Delegated Report		Analysis sheet		Expiry Date:		14/07/2020	
		N/A / attached		Consultation Expiry Date:		N/A	
Officer				Application Number(s)			
Josh Lawlor				2020/2350/P			
Application Address				Drawing Numbers			
St Pancras Coroners Court St Pancras Gardens Camley Street London N1C 4PP				See decision notice			
PO 3/4	Area Team Signature	C&UD	Authorised Officer Signature				
Proposal(s)							
Amendments to planning permission ref. 2018/5713/P granted on 24/05/2019 for 'partial removal of the front concrete boundary wall to St Pancras Gardens and construction of a two-pass ramp to provide disabled access into St Pancras Gardens off Camley Street', namely to carry out various alterations to plan, elevation and detailed design.							
Recommendation(s):		Refuse NMA					
Application Type:		Non-Material Amendments					
Conditions or Reasons for Refusal:		Refer to Decision Notice					
Informatives:

1.1. This application seeks permission to make the following amendments to planning permission reference 2018/5713/P, dated 24/05/2019 (Partial removal of the front concrete boundary wall to St Pancras Gardens and construction of a two-pass ramp to provide disabled access into St Pancra

Figure 1 OS map 1963-88

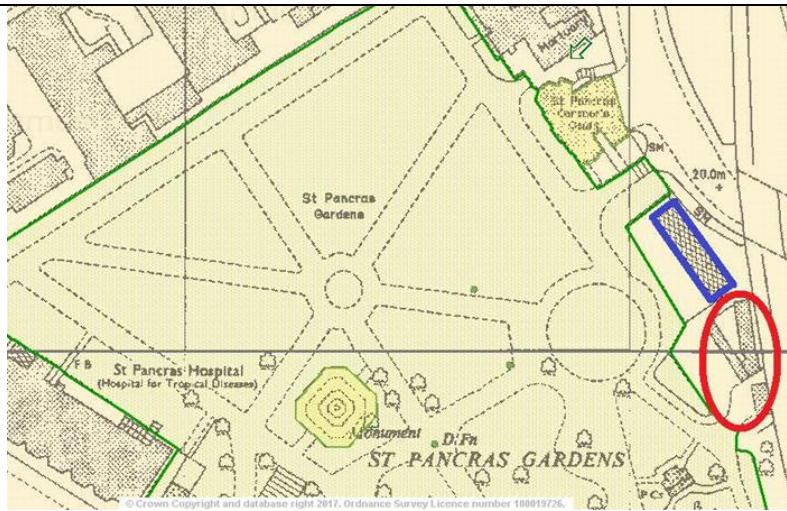
- 3.2. The OS map from 1963-88 shows the boundary of St Pancras Gardens now cutback to its current extent. The land between the garden and the railway line has been extended and is now occupied by a large (but different) glasshouse (highlighted in blue) and ancillary buildings (circled in red). A small section of the original garden wall shown on the earlier OS maps remains adjacent to the northern corner of the glasshouse and is still present today.
- 3.3. The gates were deliberately set diagonally across the path so that when open, which is how they will mostly be seen, would sit back against the adjacent walls. The amended positioning in the gates is partly due to the loss of the swept wall structure. The straightening of the gates is regarded as the loss of an interesting and characterful feature of the overall design.
